Irwin Thomas M2016-0054 TR-1, Answers to CDOT Questions

TO: Colorado Department of Transportation: Tim Bilobran, David Thomas, Steven Heimmer
FROM: Landon Wilhite, Ethan Weichert, JC York Calvin Miller, Barb Brunk Christian Morgan, Barb Brunk
DATE: May 12, 2023
RE: Colorado Department of Transportation (CDOT) questions regarding Colorado Department of Reclamation Mining and Safety (DRMS) Irwin Thomas 112 Permit M2016-054, Technical Revision #1

Exhibit A. Drawdown and mounding after completion of mining and site reclamation.

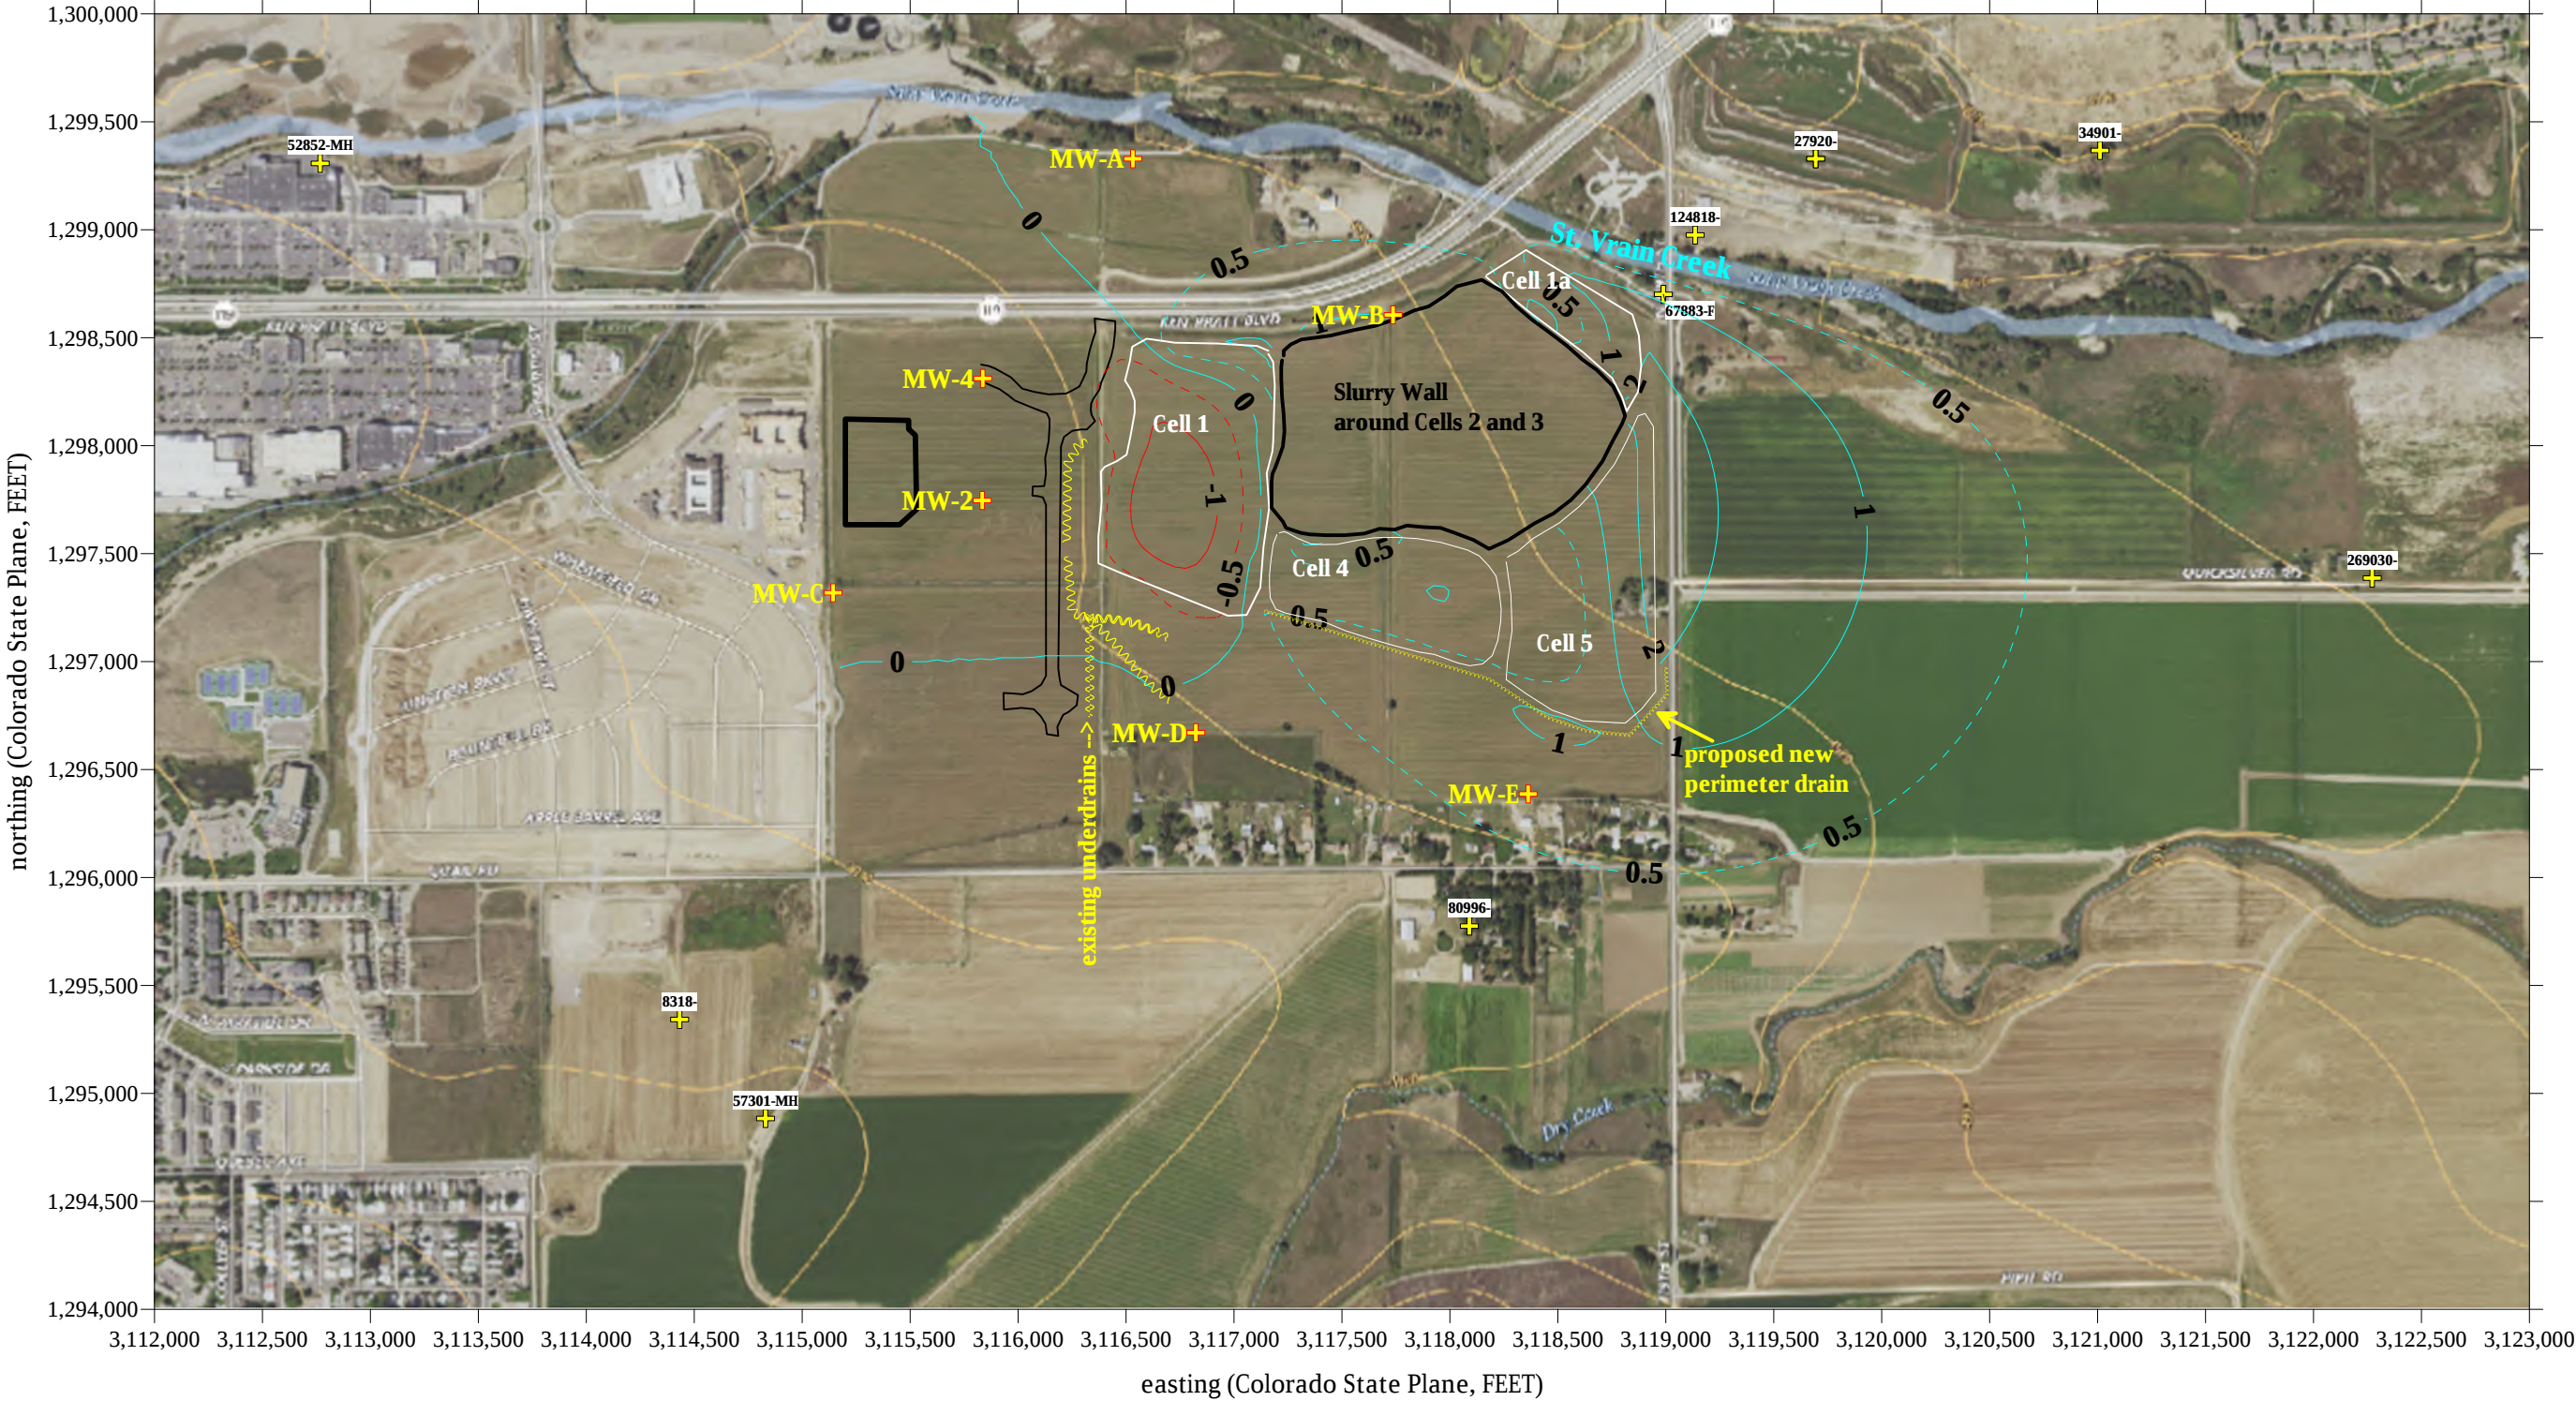
2. They state when they are going to reclaim it, it will become sealed or unlined ponds, what is the long-term effect on HWY 119 if it is saturated due to these ponds.

Maps showing water table elevations before and after mining are included in our report dated March 3, 2023. Here we highlight Figure 9 from that report by presenting it as **Exhibit A** of this report. To construct Exhibit A, we simulated groundwater flow and water table elevations for current conditions (Figure 5 of our March report) and after mining is complete (Figure 7 of our March report). The difference in groundwater levels between the two conditions is shown via contour lines in Exhibit A.

Figure 8. Model Scenario 4: Drawdown and mounding with backfilled cells, slurry wall, and Cells 4 and 5 being dewatered.

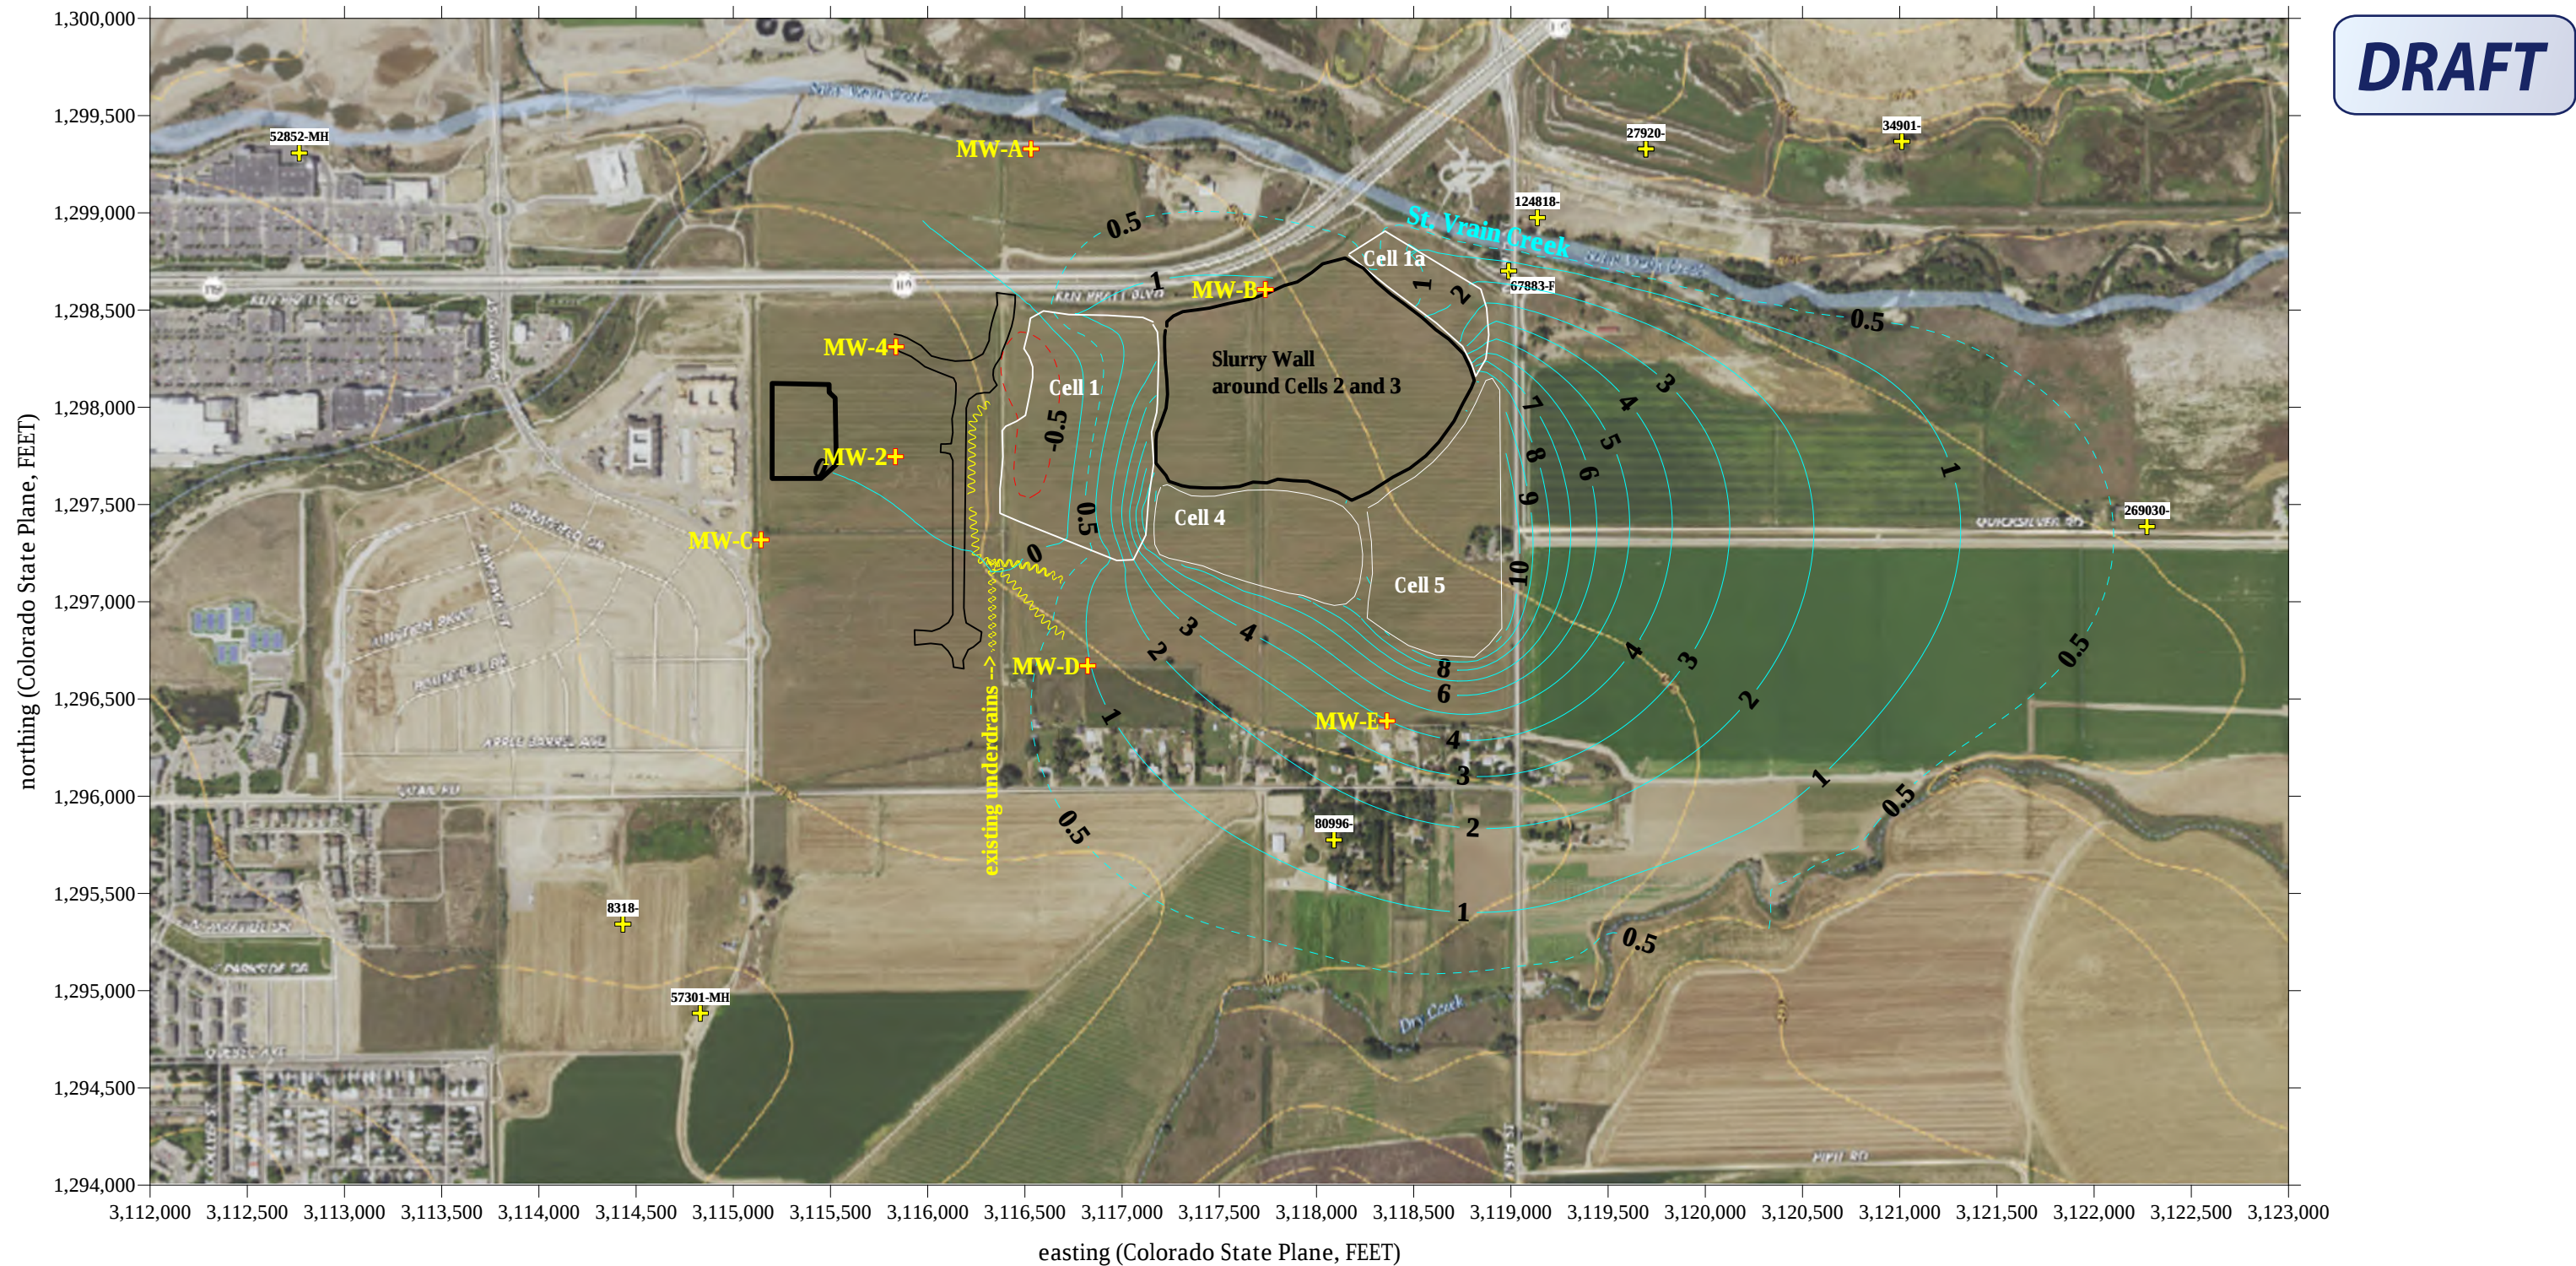
6. It is assumed groundwater is being pumped. What happens when mining ends and the groundwater rises? ***Applicant Response: Impacts on water levels are shown on Figures 8 and 9 of the Groundwater Evaluation. Water level under HWY ROW will be drawn down 0 to 1 foot during mining (Figure 8) and 0 to .5 feet (Figure 9) when reclamation is complete. No mounding under the HWY ROW was identified in the model. Following our discussion, Miller Groundwater Engineering prepared the attached letter dated April 13, 2023 to further clarify anticipated impacts to groundwater under HWY 119 adjacent to the mine.***

will be drawn down 0 to 1 foot during mining (Figure 8) and 0 to .5 feet (Figure 9) when mining is complete. No mounding under the HWY ROW is identified in the model.

Applicant Response: *The attached Groundwater Analysis prepared by Miller Groundwater Engineering, for the south side of the HWY, demonstrates impact to the water table with Mining and Reclamation, including installation of the slurry wall. The highway now sits on top of existing groundwater (see Figure 5 in the Model – existing water table is between 10 and 20' deep under the HWY ROW). Impacts on water levels are shown on Figures 8 and 9. The water level under HWY 119 ROW will be drawn down 0 to 1 foot during mining (Figure 8) and 0 to .5 feet (Figure 9) when mining is complete. No mounding under the HWY ROW is identified in the model. Following our discussion, Miller Groundwater Engineering prepared the attached letter dated April 13, 2023 to further clarify anticipated impacts to groundwater under HWY 119 adjacent to the mine.*
